## Planning Application No. A/YL-SK/466

Table A: Responses to Departmental Comments

Proposed Temporary Shop and Service and Associated Filling of Land for a Period of 3 Years at Various Lots in D.D.114, Shek Kong, Yuen Long, N.T.

Land Filling Plan

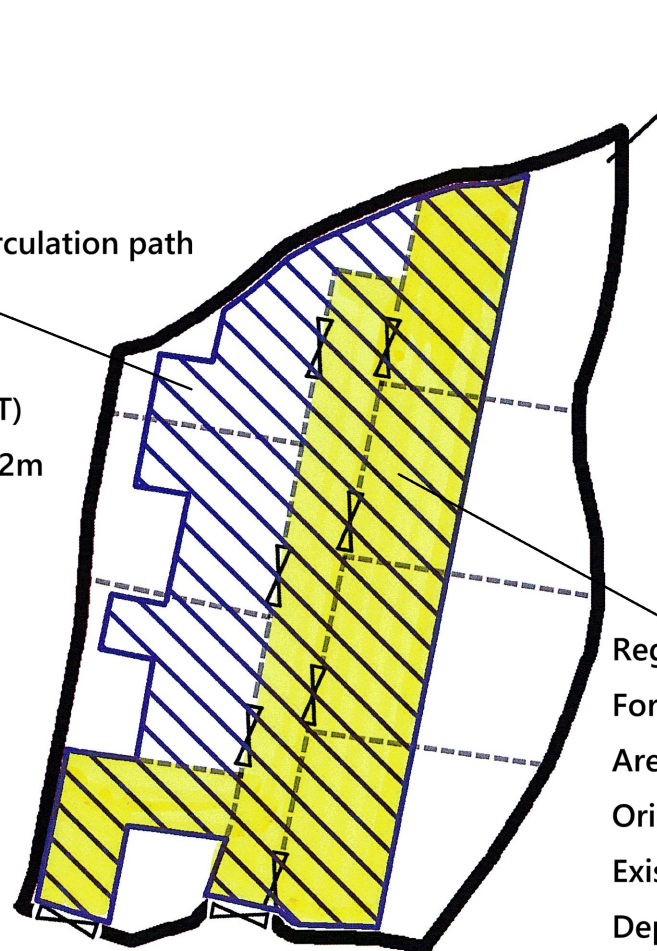
|   | Departmental Comments                                                                                                                                                                                                                                                                                               | Responses                                                                                                                                                                                                                                           |
|---|---------------------------------------------------------------------------------------------------------------------------------------------------------------------------------------------------------------------------------------------------------------------------------------------------------------------|-----------------------------------------------------------------------------------------------------------------------------------------------------------------------------------------------------------------------------------------------------|
| 1 | It is noted that the application applies for filling of land of a total area of about 1,050m <sup>2</sup> (about 64% of the Site). Please clarify on the area intended for proposed land filling and that intended for regularization of land filling, and please update the relevant plan/drawing, as appropriate. | <p>擬議申請的總填土面積約為 1,050 平方米，區分如下；</p> <ol style="list-style-type: none"> <li>1. 已填土部分規範化的面積<br/>(Regularization of land filling) 約為 650 平方米 (圖則中以黃色標示)</li> <li>2. 擬議填土的面積 (Proposed land filling) 約為 400 平方米</li> </ol> <p>有關上述兩部分的具體位置，請參閱附件 1。</p> |

Proposed Land Filling Area ( 400m<sup>2</sup> )

Regularization of land filling ( 650m<sup>2</sup> )
